RFI

RFI #: 119  
 Date: 5/17/2012  
 Job: EB-02 Keller Springs Lofts  
 Phone: 877-777-5115

Subject: Reinforcement Between Garage and Elevator #2

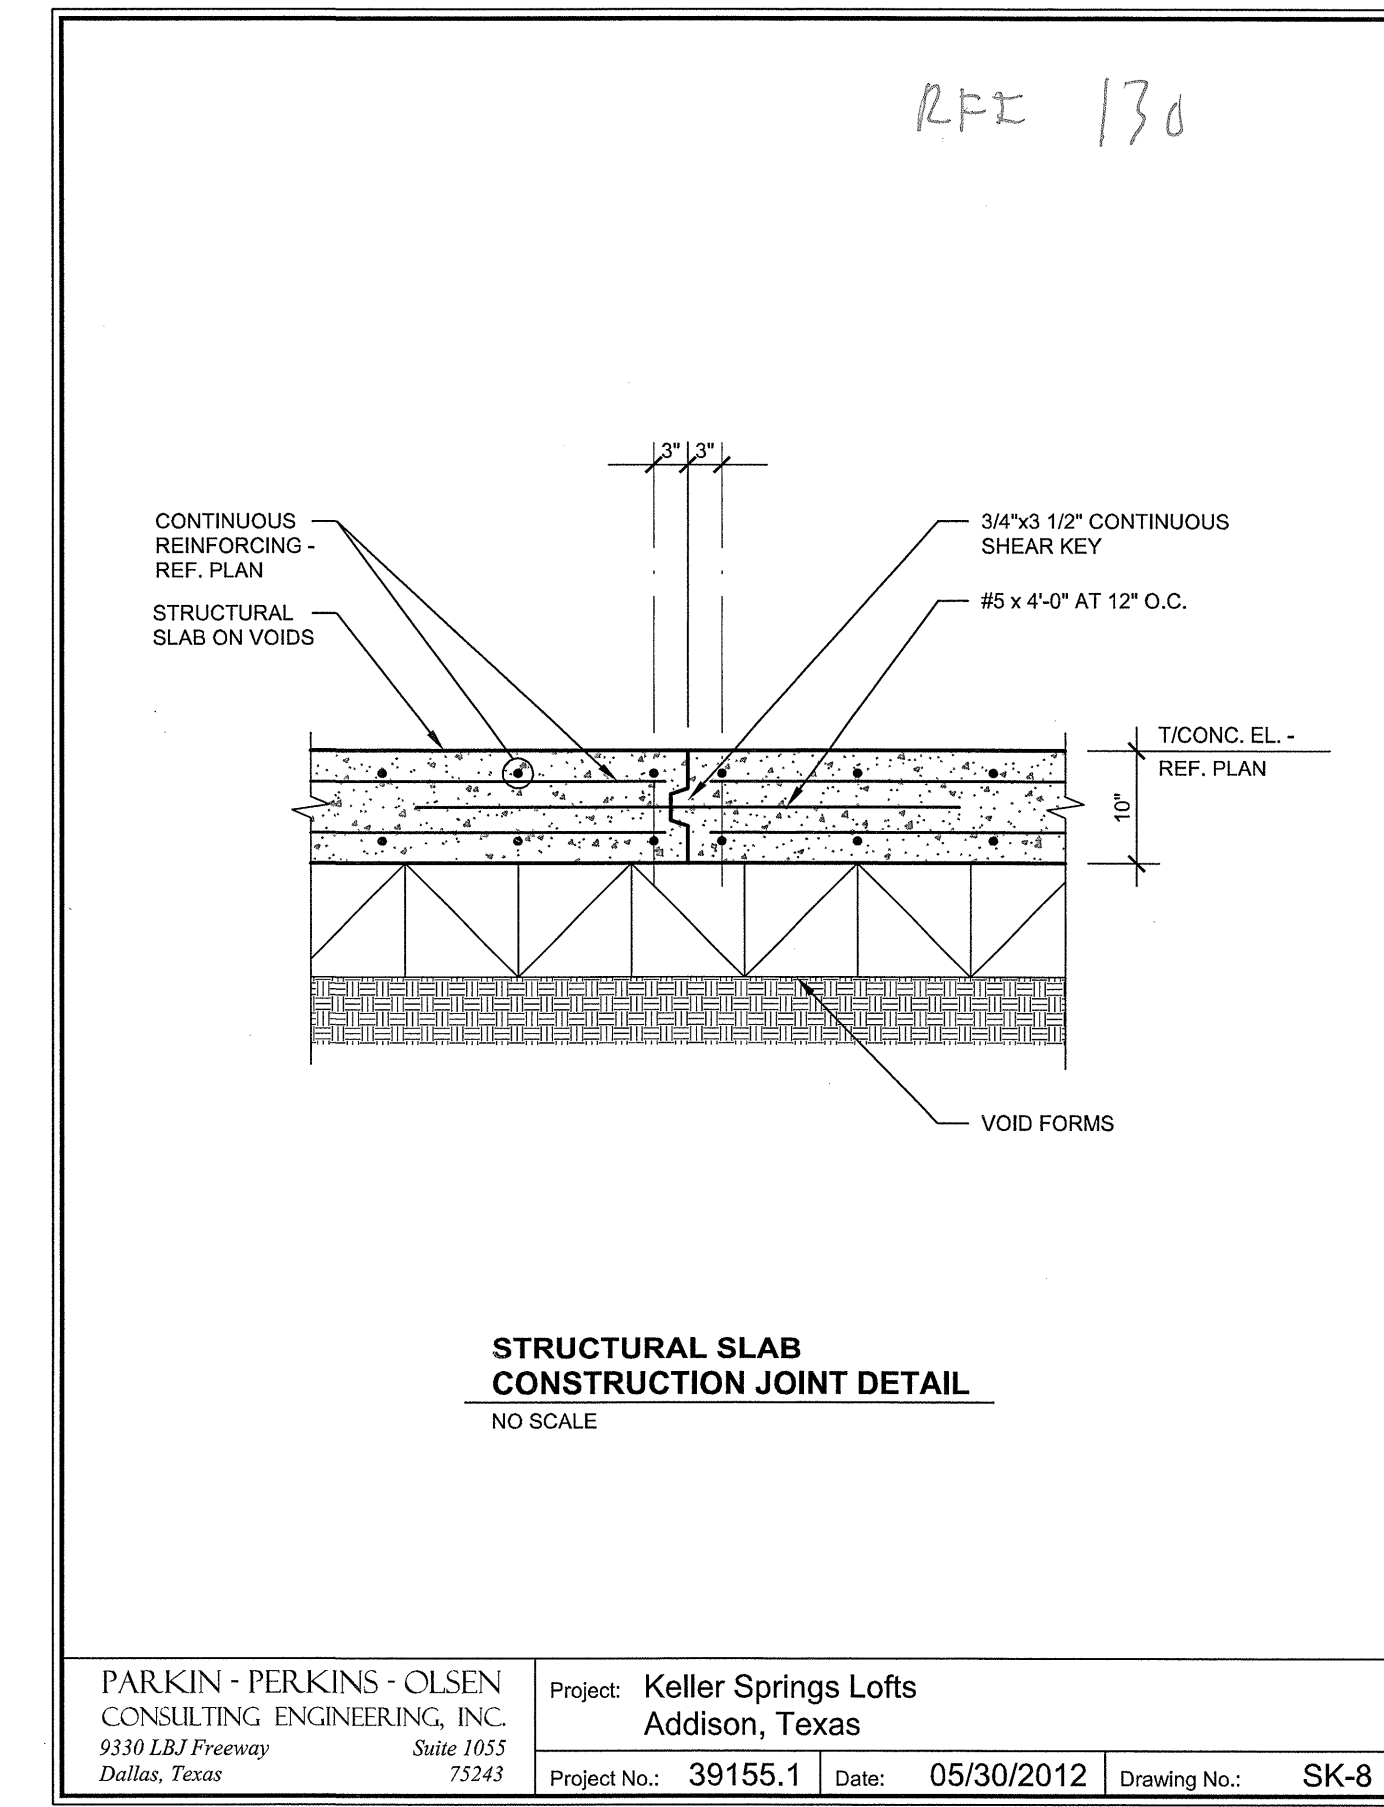
**Request:** Date Required: 5/24/2012  
 Please provide a detail sketch showing the proper number and placement of dowels to tie the elevator back wall into the beam wall of the garage. S2.14 shows using 11/S3.03 at the NW & SW corner of the pit adjacent to the garage. Please provide a sketch for clarification purposes on the elevator wall butting into the garage.

\*\*While on site on Thursday, May 24, it was observed that the concrete subcontractor had drilled and epoxy grouted #4 dowels at approximately 18" o.c. horizontally and vertically in the garage foundation wall to tie into the elevator pit wall. He was preparing to install 2-#4 dowels at 12" o.c. vertical in the garage foundation wall to tie into the intersecting elevator pit walls. Refer to the attached photo. The proposed solution is acceptable to PPO.

\*\*It was also discussed while on site that the 8" wide elevator pit wall adjacent to the garage foundation wall shall be reinforced with #4 bars at 12" on center, each way, and centered in the wall.
